TO: T10 Membership
FROM: Paul A. Suhler, Quantum Corporation
DATE: 9 March 2008
SUBJECT: T10/07-469r1, ADT-2: Internet ADT (iADT)

Changes to ADT-2 rev. 5

Figure 12 – Example of shared iADT socket in an automation device

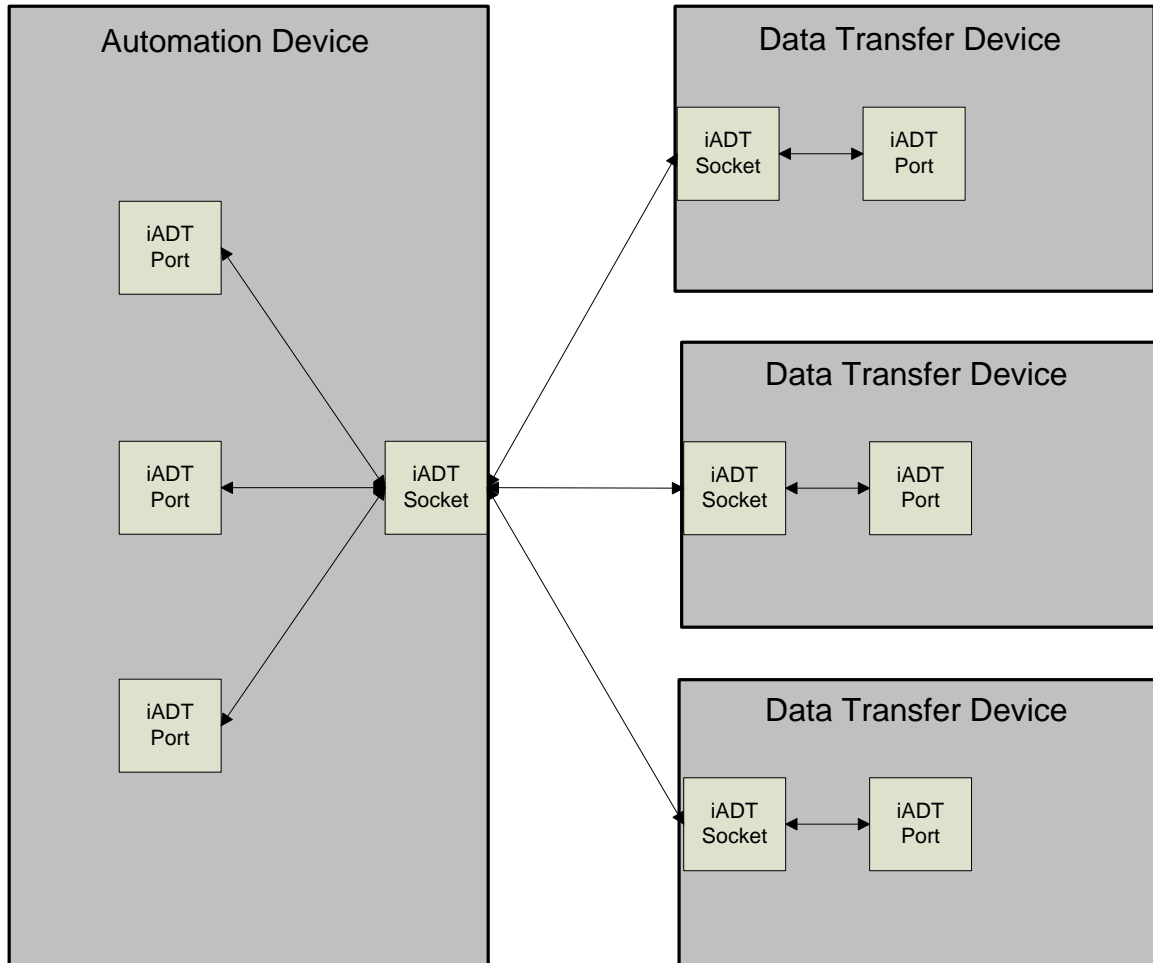
One physical network port may respond to multiple internet addresses, and thus may contain multiple iADT sockets, one for each of the internet addresses. If a device (e.g., device A) contains only one iADT socket (i.e., there is one Ethernet port and it responds to a single internet address) then that iADT socket may be connected to iADT sockets in different devices. Each of those iADT connections connects to a different ADT port in device A. (See Figure 12.)

Editor's Note 3: Should some of this go in the model section?
